**ARCHITECTURAL REVIEW BOARD
CITY OF FREDERICKSBURG, VIRGINIA
AGENDA
February 10, 2020
7:00 P.M.
COUNCIL CHAMBERS, CITY HALL**

TO: ARCHITECTURAL REVIEW BOARD
FROM: Kate Schwartz, Historic Resources Planner
DATE: February 5, 2020 (for the February 10, 2020 hearing)
SUBJECT: Certificate of Appropriateness for accessory structures at 303 Fauquier Street

TO: ARCHITECTURAL REVIEW BOARD
FROM: Kate Schwartz, Historic Resources Planner
DATE: February 5, 2020 (for the February 10, 2020 hearing)
SUBJECT: Certificate of Appropriateness for demolition/new construction at 1005 Sophia St.

- DARK STAR SALOON -
 BOB FAVORIER ST.
 FREDERICKSBURG VA 22401
 DESIGNER: GREG GALLAGHER
 540-850-8545
 OUTDOOR PLATFORM -

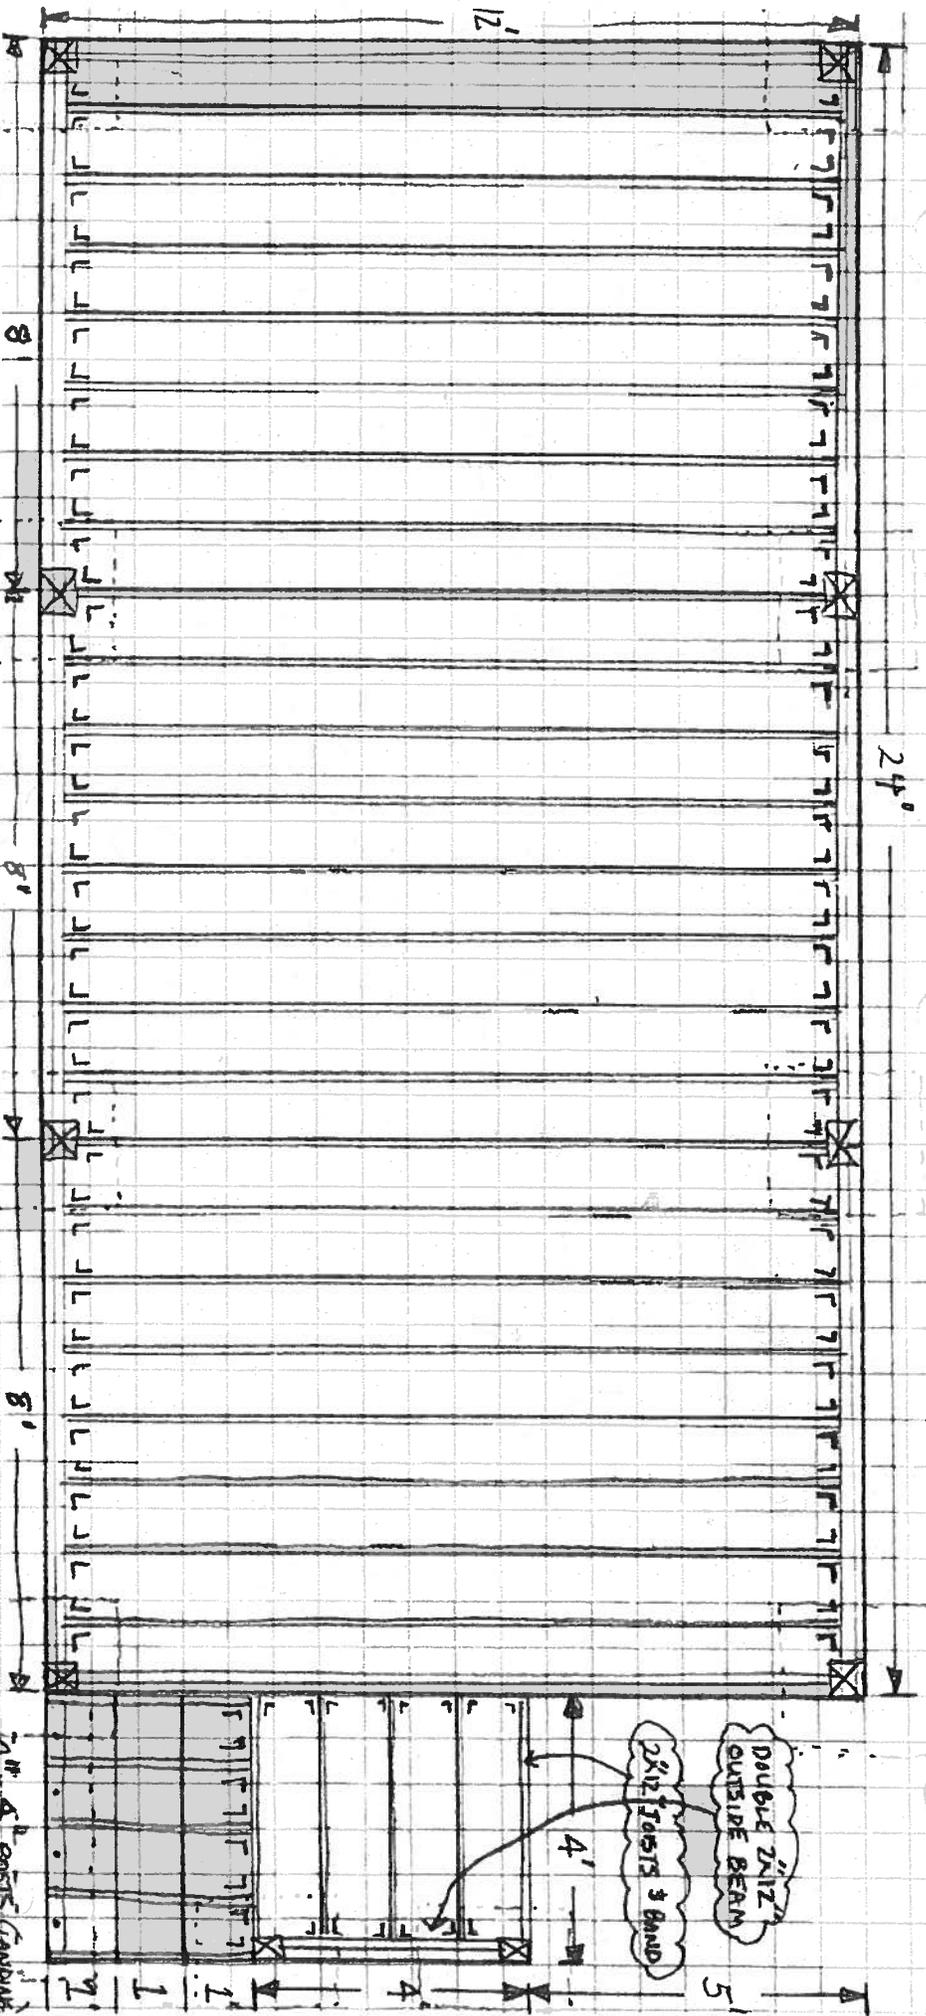
The structure occupies approximately 68% of the required rear yard setback. The existing primary structure has setbacks of four feet from the east side and two feet from the west side. The stage structure is set 2.5 feet off of the rear property line, one foot off the west side property line, and one foot eight inches off the east side property line. It is recommended that the request to retain the bar structure be continued to allow the applicant to provide additional information. It is recommended that the request to retain the stage structure be denied. The stage must be removed, or a modified design that meets the requirements of the code must be approved by the ARB.

Example steps showing proposed construction details

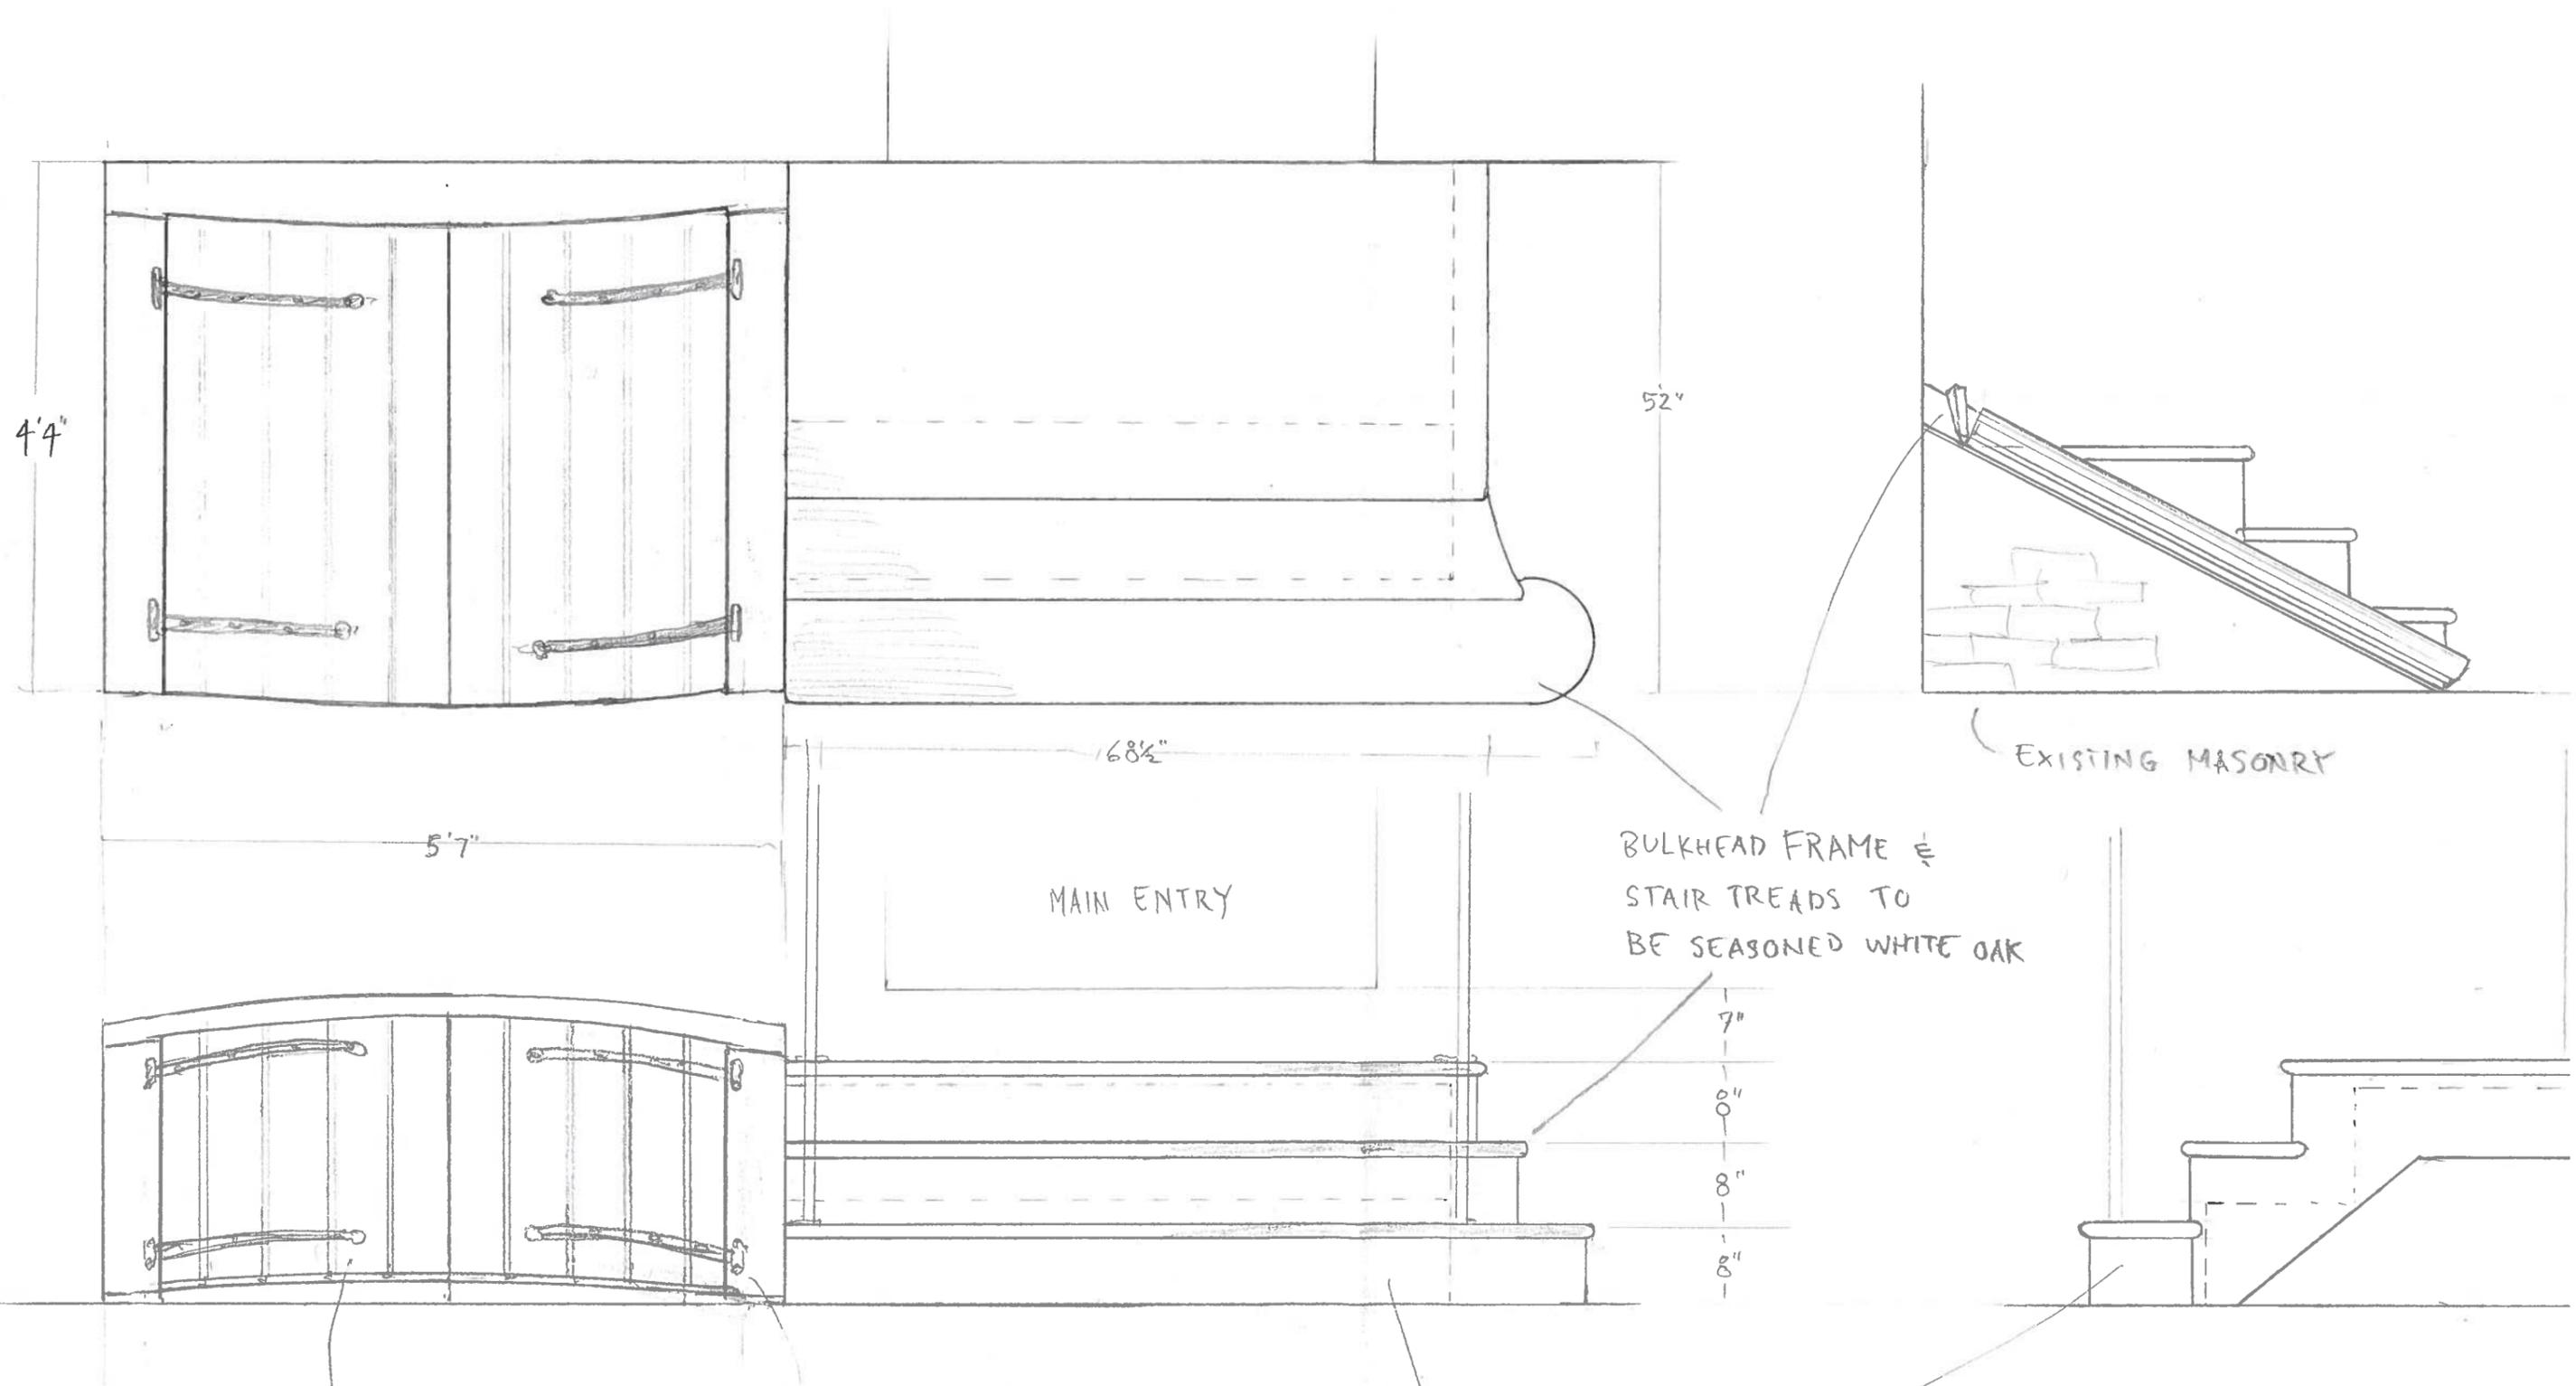
The new steps and bulkhead entry proposed match the dimensions of the existing; however, some details are proposed to be altered. The bulkhead frame and stair treads will be constructed of seasoned white oak; the risers and north side will be painted, salt-treated pine; and beaded tongue-and-groove doors constructed of painted, salt-treated pine or cypress will replace the board-and-batten bulkhead doors. Each step will include a bullnose edge, and the lowest step will include an extended, rounded end on the north side. The existing iron handrails will be reused. New hardware will be installed on the bulkhead doors, including hand-forged iron strap hinges. The original sandstone steps will remain in place beneath the new steps and will not be impacted. The original steps will be visible at the north side of the new steps.
